CALIFORNIA ENERGY COMMISSION

PRELIMINARY REPORT

NCPA GEOTHERMAL PROJECT No. 2

78-NOI-5

MAP 1

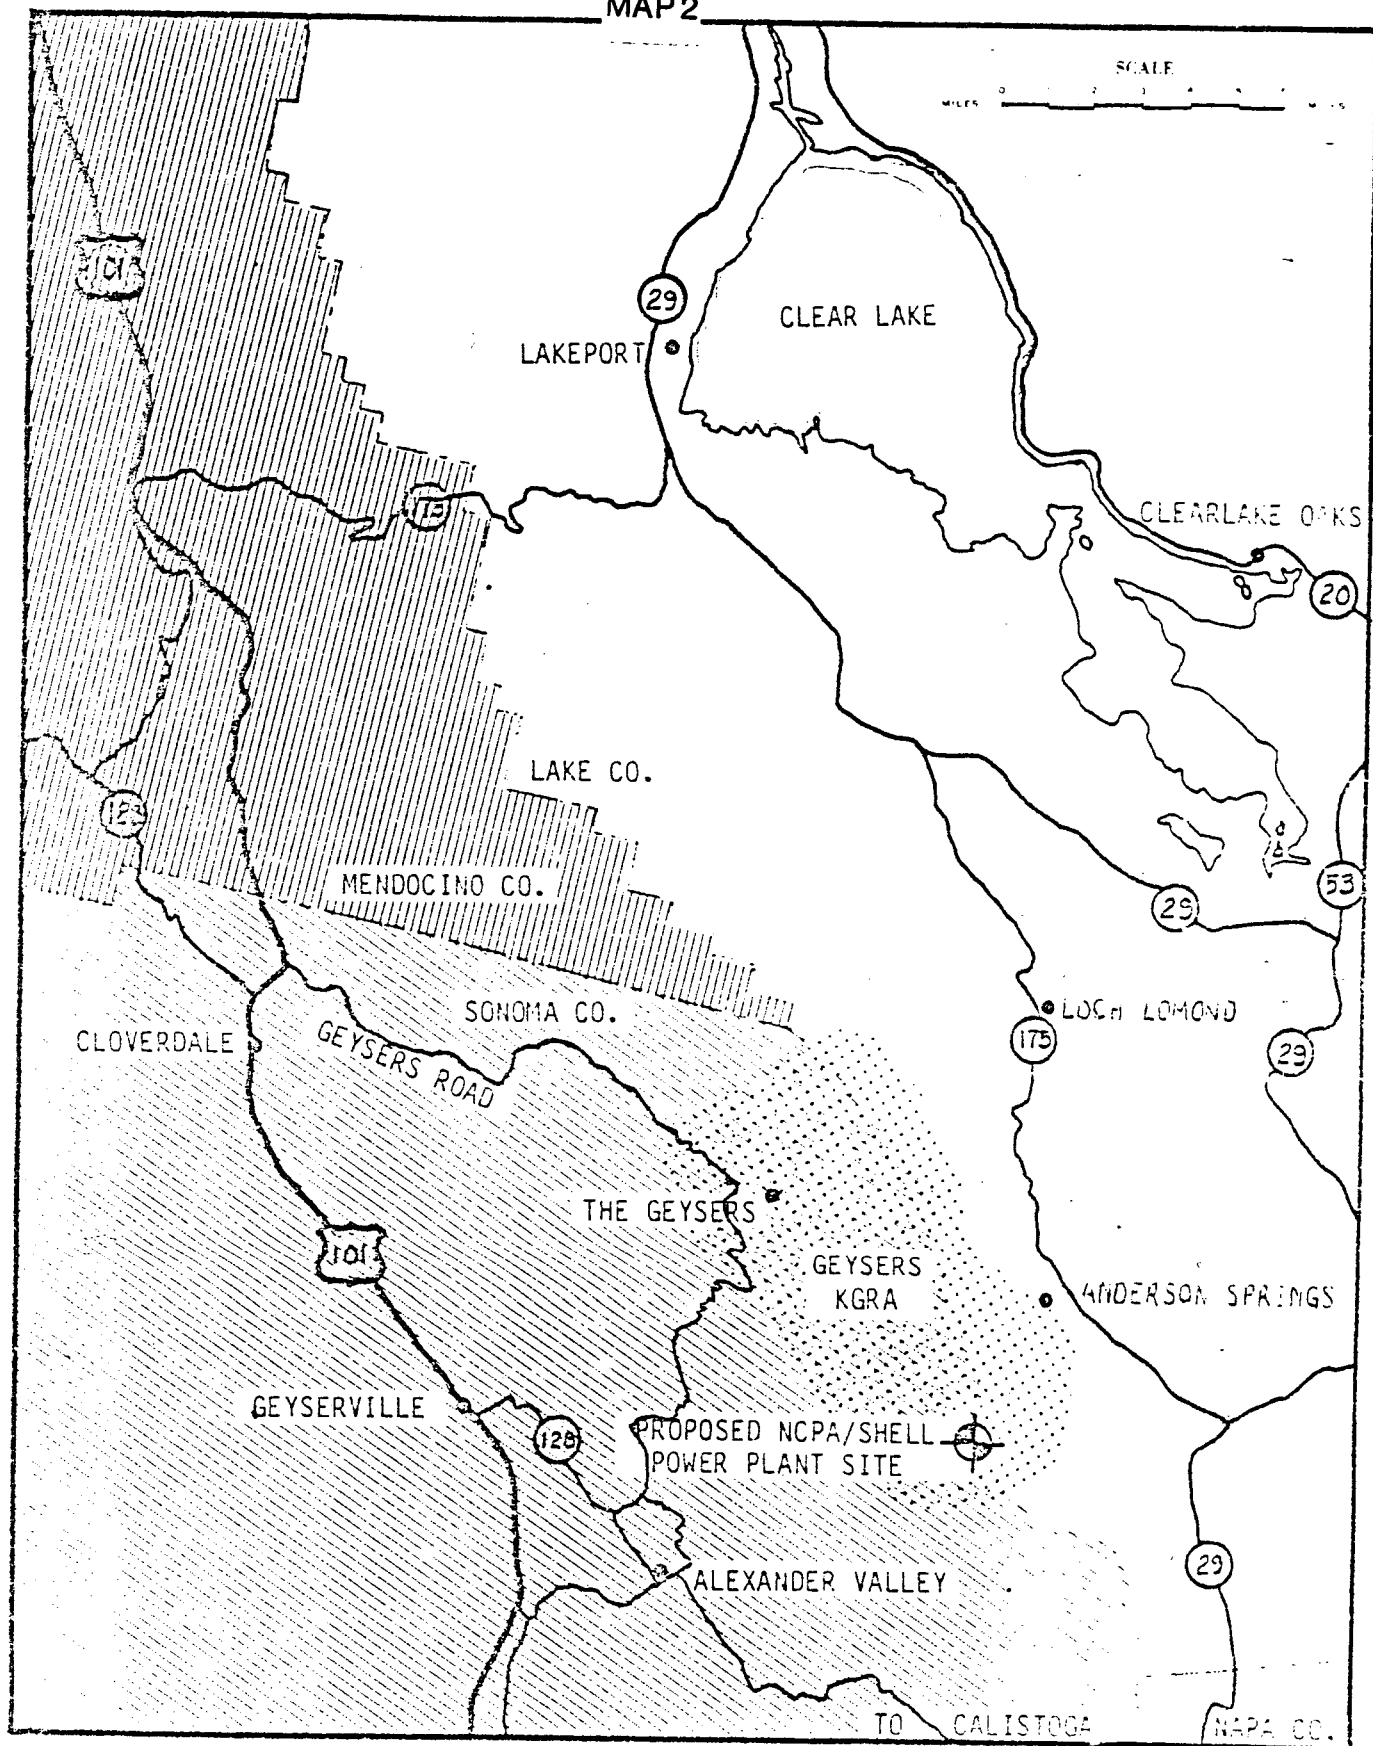
*The Committee is confused as to whether the Transmission capacity out of the Geysers area will or will not be via currently existing routes.
